Use on Review 10-A-18-UR

File# 10-A-18-UR

(Rezoning of 7943 Pelleaux Rd, Knoxville, Tn 37938 from vacant land to PR 3 lots)

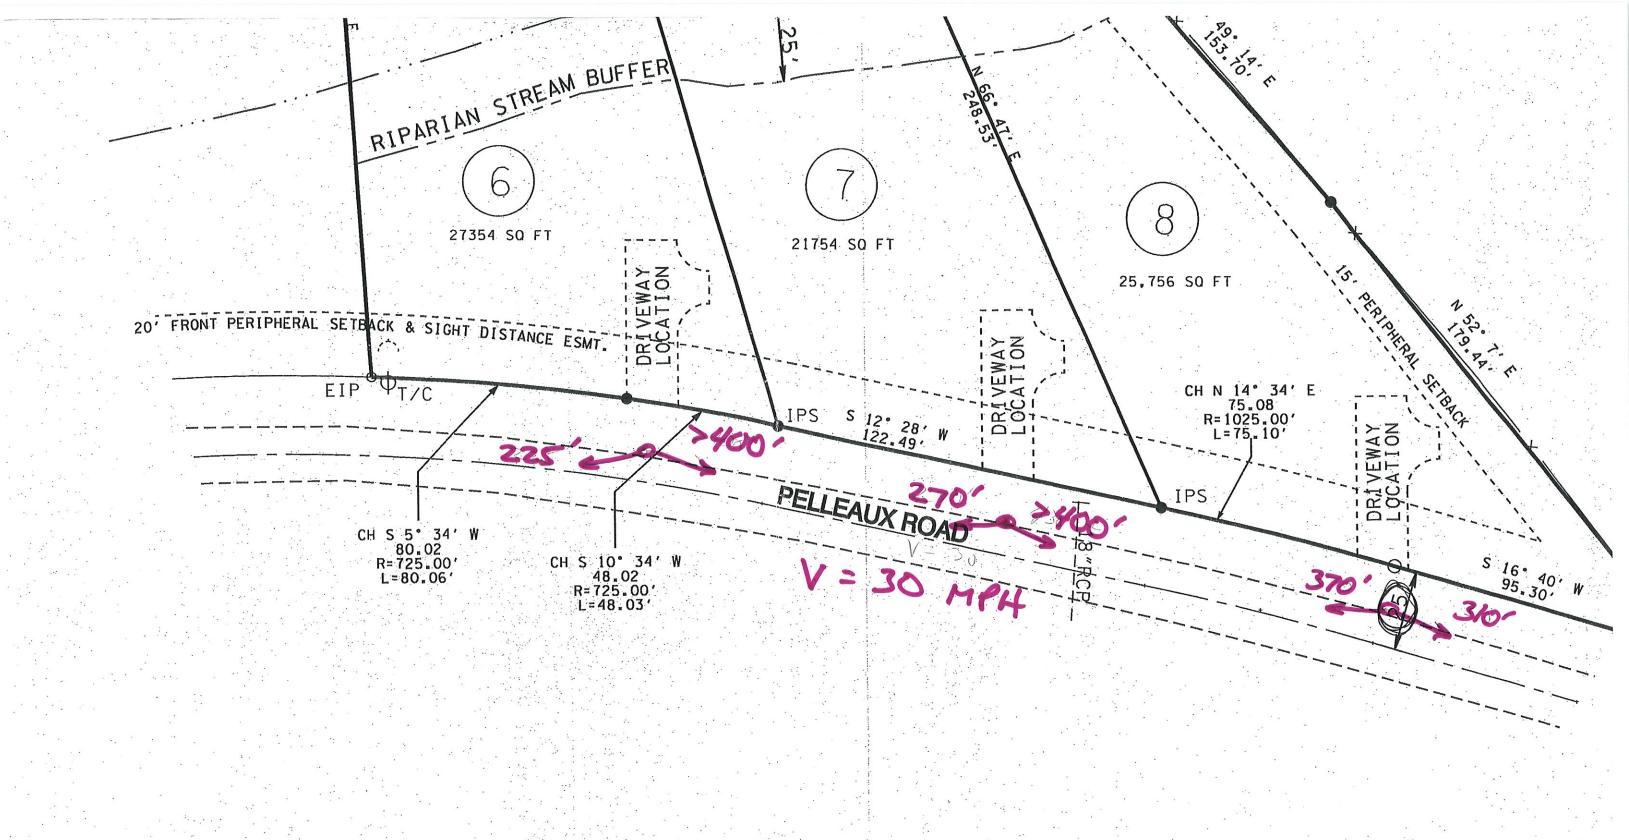
This is in regard to sight distance at the three new lots on Pelleaux Road being created by the subject re-subdivision. Garret Tucker of Robert G. Campbell and Associates had staked the property corners and driveway centerlines for each of the three lots (#s 6, 7 and 8). I checked the available sight distance at each driveway location. All measurements were made at the edge of Pelleaux Road using a driver's eye height of 3.5 feet and an approaching vehicle target height of 3.5 feet. The posted speed limit on Pelleaux Road is 30 MPH, so the required sight distance is 300 feet. The table below summarizes my findings, and I have attached a figure for clarity.

Lot #	Sight distance		Comments	
	To left (south)	To right (north)		
6	Greater than 400 feet	225 feet	Sight distance to right is	
			restricted by combination of	
			crest vertical curve and	
			horizontal curve with cut bank.	
7	Greater than 400 feet	270 feet	Sight distance to right is	
			restricted by combination of	
			crest vertical curve and	
			horizontal curve with cut bank.	
8	310 feet	370 feet	Sight distance to right is	
			restricted by crest vertical	
			curve. Sight distance to left is	
			restricted by vegetation within	
			site frontage and on adjacent	
			property.

Based on my field review there are some deficiencies. I will be glad to meet with the engineer in the field to discuss these findings. Let me know if you have any questions.
